Reply to comments by Reviewer 1: "Estimating the impact of ice sheet surface height and ice divide variability on ice core based climate reconstructions"

Summary of Changes

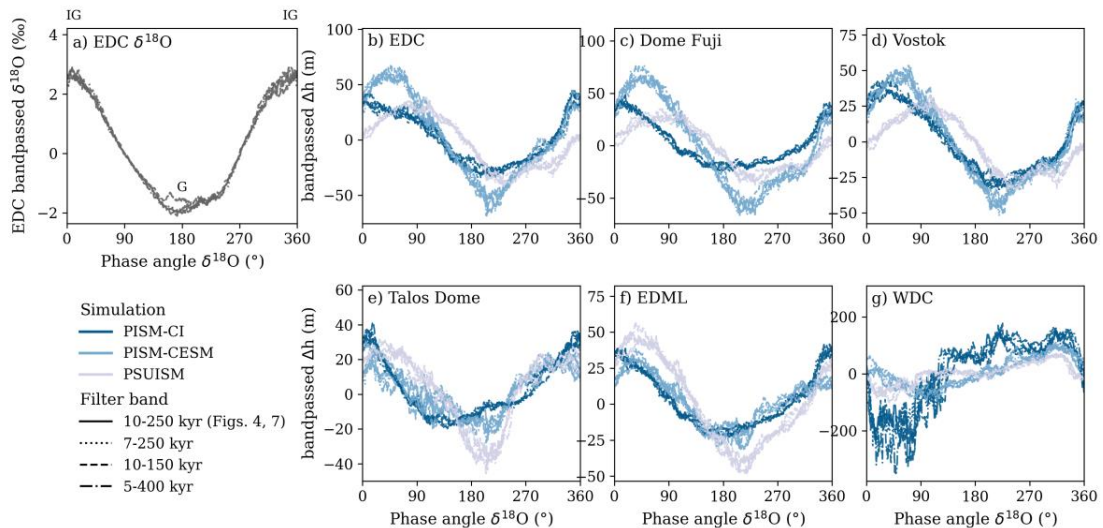
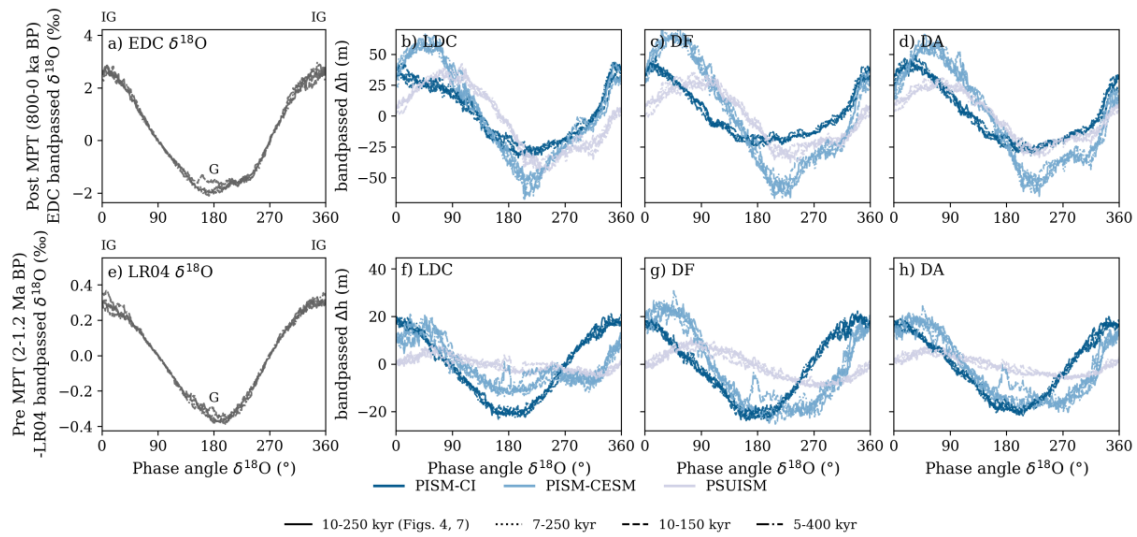
10. Section 3.1 — phase-shift estimates (Fig. 4/7) — The magnitude of the reported phase/timing shifts (e.g., “up to 45 kyr” for PSUISM at the Last Interglacial) is presented as a point estimate derived from a single, fixed bandpass filter (7–250 kyr). It would strengthen confidence in the quoted values if the authors briefly indicated the sensitivity of the phase-shift magnitudes to reasonable variations in the filter band (e.g., a narrower or wider cutoff) or justified why 7–250 kyr was chosen as the appropriate band.

Reply: The band was chosen to retain the precessional, obliquity and eccentricity periods that dominate both the isotope records and the simulated Δh , and to exclude millennial variability and the long-term trend, the exact cutoffs within these limits are a choice. To validate the robustness of our method to the choice of the cutoff frequencies we repeated the phase analysis for a narrower (10–150 kyr) and a wider (5–400 kyr) band, applying each band identically to the $\delta^{18}O$ record and to Δh , and show the composites for all bands in Fig. R1 below, which we propose to add to the appendix of the manuscript. As Figure R1 underlines our statements on the phase and time shifts are robust under varying cutoff windows.

While performing the additional analysis, we realized that the cutoff window used in Figure 4 and 7 was 10–250 kyr instead of 7–250 kyr. We will change this accordingly in the revised manuscript.

Figure R2. Ice divide composites as in Figs. 5 (top) and 8 (bottom) for velocity thresholds of 0.25, 0.5, 1.0 and 2.0 m yr⁻¹ (line styles) in PISM-CI (grey) and PISM-CESM (purple) over the simulated present-day PISM-CI velocity field. Crosses mark the drill sites.

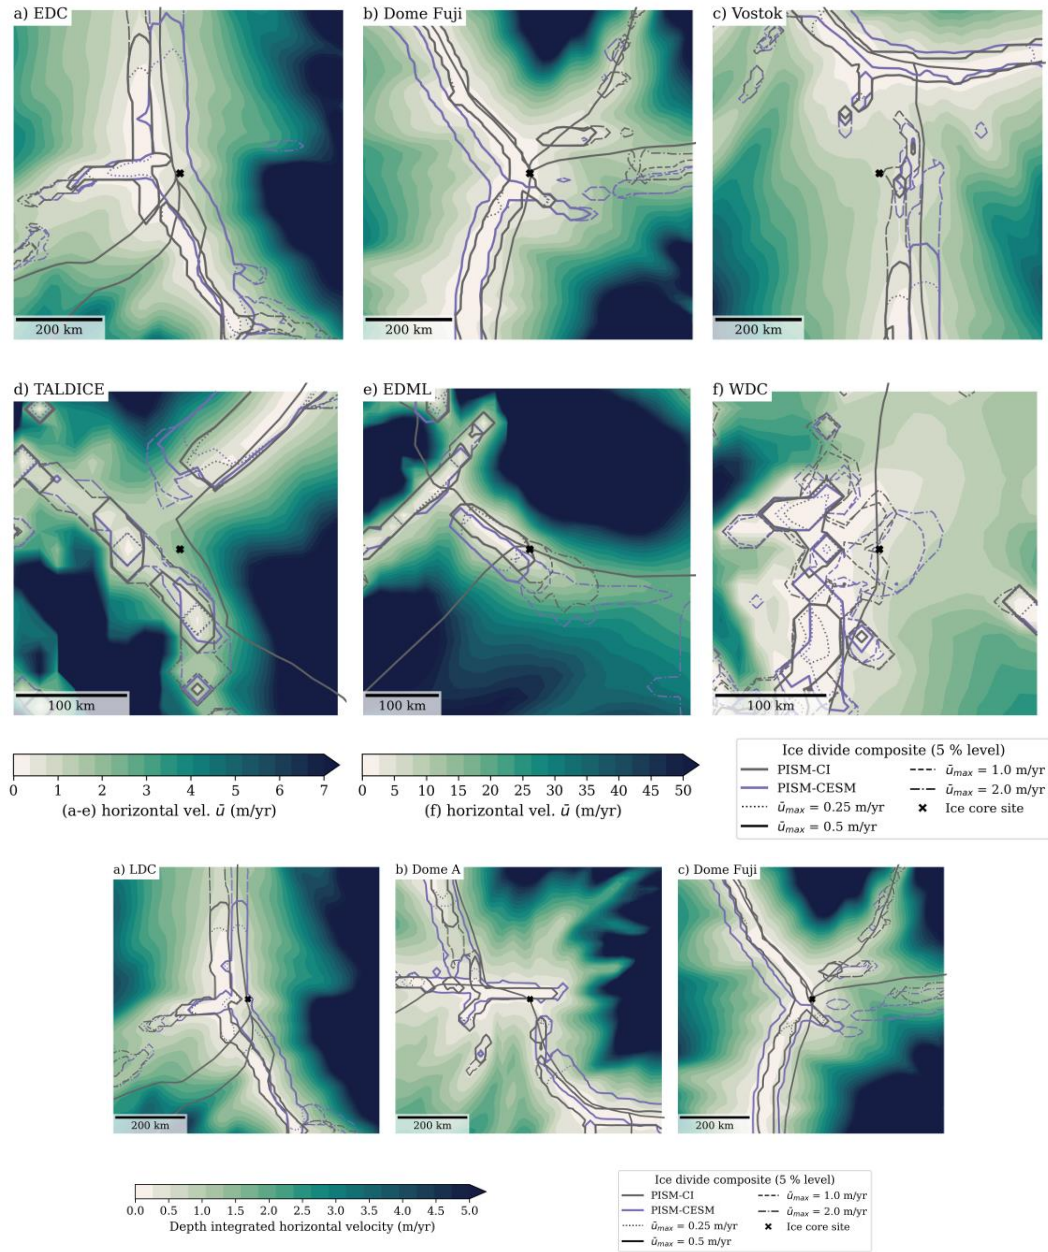
15. Section 3.2 — *The divide-detection method uses a fixed velocity threshold ($\bar{u}_{\max} = 0.5$ m/yr), but no justification is given for this value. It would be helpful if the authors could briefly explain why 0.5 m/yr was chosen or ideally include a short sensitivity check showing how much the reported displacement estimates would change under a different reasonable threshold.*

Reply: The threshold is used only for the ice divide detection. The dome position is detected via the local surface height maxima and does not depend on the threshold. Since the divide lies somewhere within a grid cell, the model does not produce a cell with zero velocity, and a threshold is needed to identify it. 0.5 m yr⁻¹ keeps the detected divide as narrow as possible while still captures it mostly continuous at all sites. A sensitivity analysis is done in Fig. R2, which shows the divide composites for $\bar{u}_{\max} = 0.25, 0.5, 1.0$ and 2.0 m yr⁻¹. We propose to add both figures to the appendix of a revised manuscript.

Proposed text: “... as long as it is lower than a threshold velocity of $\bar{u}_{\max} = 0.5$ m yr⁻¹, and vice versa. As the divide does not coincide with a grid cell of zero velocity, this threshold is chosen to keep the detected divide as narrow as possible while capturing it almost continuously at all sites. The sensitivity of the ice divide location to $\bar{u}_{\max}$ is shown in Fig. A3 and A4.”
